May 23, 2023

Waller County Drainage Easement Amendment Request Sand Hill Farm Mitigation Bank (SWG-2021-00571) Waller County, Texas

Figure 2. Easement proposal and relevant berms. Note the blue shaded area marks the area where berms would be able to back up water

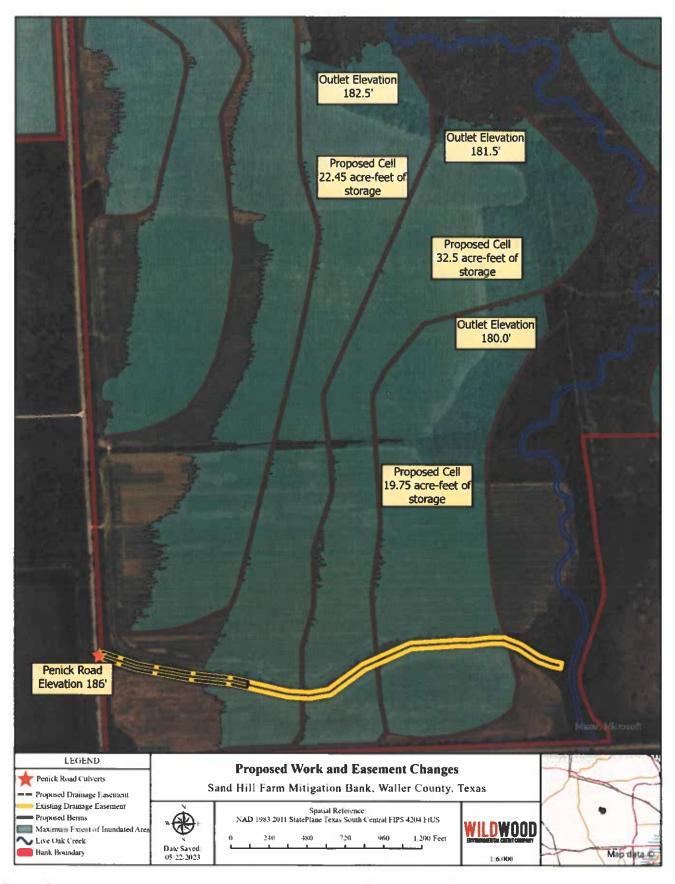
Three of these berms would cross a 40° wide drainage easement held by Waller County. The existing easement dates to 1953 and is shown on **Figure 2.** Waller Land & Cattle requests the drainage easement be amended to shorten its length from the current 3.000 feet to 1,200 feet. This would not alter the drainage at Penick Road from its existing condition. It would allow for the creation of approximately 75 acre-feet of storage at the site. Without the amendment, wetland cells will need to be constructed around the drainage easement. Amending the easement as depicted would be mutually beneficial to both parties by improving drainage from the road compared to its current condition and also increasing flood retention along Live Oak Creek.

Wildwood previously had two meetings with Yancy Scott to discuss the potential easement amendment. At Mr. Scott's request, we have increased the length of the remaining ditch from 150 feet to 1,200 feet. We also removed one of the berms from the plans to allow for more conveyance from the county road. Mr. Scott also requested us to calculate the storage volumes that would be created by the wetlands which we determined to be approximately 75-acre feet directly associated with the easement amendment. **Figure 2** is a map of this information.
